McLEOD MINI
WAREHOUSES

REF: McLEOD MINI WAREHOUSES (F17-D35)

RE: MCLEOD MINI WAREHOUSES (F17-D35)

These are my comments on the plan as revised February 2, 1984.

EMERGENCY OVERFLOW SPILLWAY

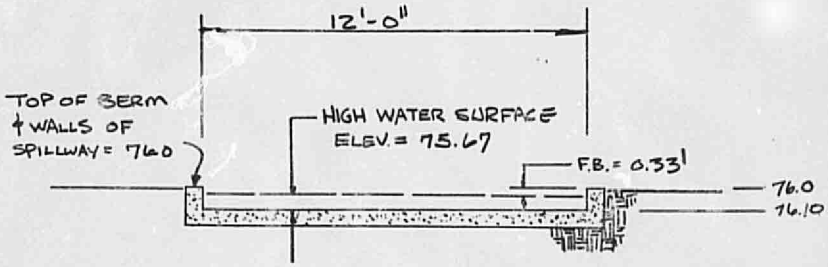
1. The overflow spillway needs to be wider. It must be capable of conveying the 100 year Q, with freeboard, in the event the 4" pipes are clogged.

- ASSUME CONTROL DISCHARGE (3 - 4" PIPES) IS BLOCKED
- SIZE SPILLWAY TO HANDLE Q_{100} = 15.7 CFS
  F.B = 0.33' (4")

FOR A 12' WIDE (INSIDE DIMENSION) SPILLWAY

$Q = 3.087 L H^{3/2}$

$= 3.087(12)(0.57)^{3/2}$; WHERE 0.55 IS THE DEPTH OF FLOW

$= 15.9$ CFS

15.9 > 15.7 ——————— O.K.

TOP OF SIDE WALLS OF SPILLWAY	=	76.0
FREEBOARD (4")		− 0.33
MAX. WATER SURF. ELEV.	=	75.67
MAX. DEPTH OF FLOW.		− 0.57
SPILLWAY ELEVATION	=	75.10

SECTION A-A (REVISED)

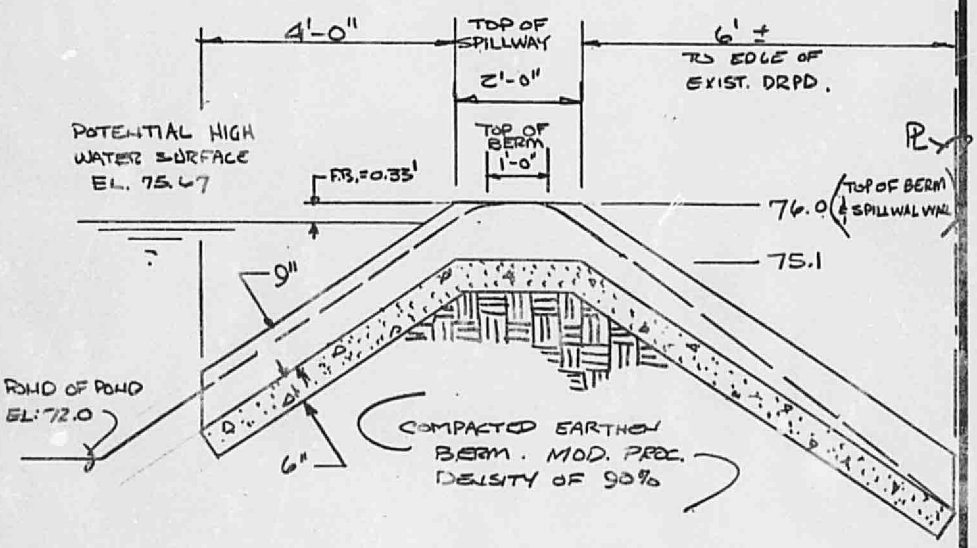
9. Section A-A on the drainage plan needs dimensions and if this is a typical section, the contours need to agree with that section.

2. The berm around the pond needs more detail:
   a. Show a section through berm, with freeboard. The calculations submitted to date show the high water level to be 76.00 and a top of berm elevation of 75.80. Also, the Q used in that weir calculation was smaller than the actual Q 100 developed.

1. MAXIMUM SIDE SLOPES OF DETENTION POND BERM SHALL NOT EXCEED 1.5 TO 1
2. TO OF BERM A ELEV. 5176.0
3. SPILLWAY SHALL BE OF P.C.C. (30 DAY TEST OF 3000 PSI)
4. 6x6 . 10 ga. WIRE MESH SHALL BE PLACED HORIZONALLY W/ 3" OF CONCRETE COVER.

POND ENTRANCE WEIRS

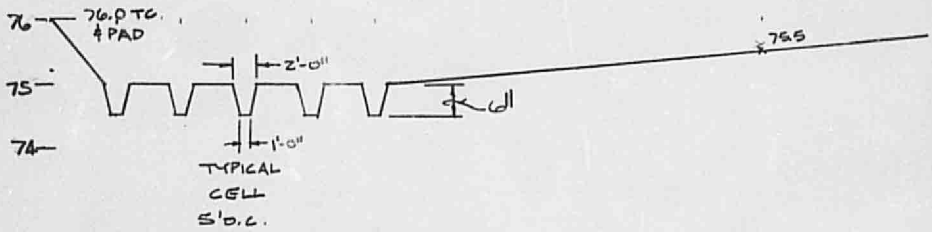
b. Show that the inlet openings in the curb can handle the flow and show top of curb elevations on all curbs.

- ANALYZE WEIR SECTIONS AND OVERFLOW POTENTIAL.
- MAXIMUM HIGH WATER = 75.67
- HIGH WATER FOR DETENTION ONLY = 75.1

INDIVIDUAL WEIR CELL ANALYSIS

$Q = 3.0 L H^{3/2}$ WHERE $L = 1.5'$ (AVERAGE WIDTH)
$H = 0.5'$

$Q = 1.6$ CFS

TOTAL FLOW THRU THE FIVE WEIRS

$5 \times 1.6 = 8$ CFS

NOW, ASSUME A 0.2' OVERFLOW OVER THE TOP OF CURB ALONG A 30 FOOT STREACH.
USE A 'C' OF 2.5

$Q = (2.5)(30)(0.2)^{3/2} = \underline{8 \text{ CFS}}$

TOTAL Q PASS THRU THE WEIRS AND OVER THEM IS 16 CFS, THEREFORE ALL FLOW CONDITIONS ARE SATISFIED FOR ALLOWING STORM WATERS TO ENTER INTO THE POND AREA.

CMU RETAINER WALL DETAIL

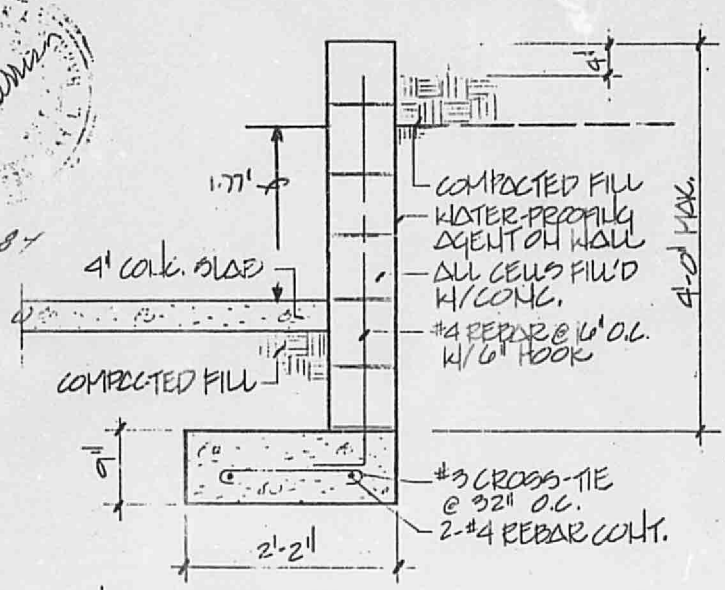
4. Show a section through walls where grade outside is above finished floor.

WORST CONDITION
GND. TO EAST = 81.1
FF = 79.33
MAX. VERT. SEPARATION = 1.77 FT
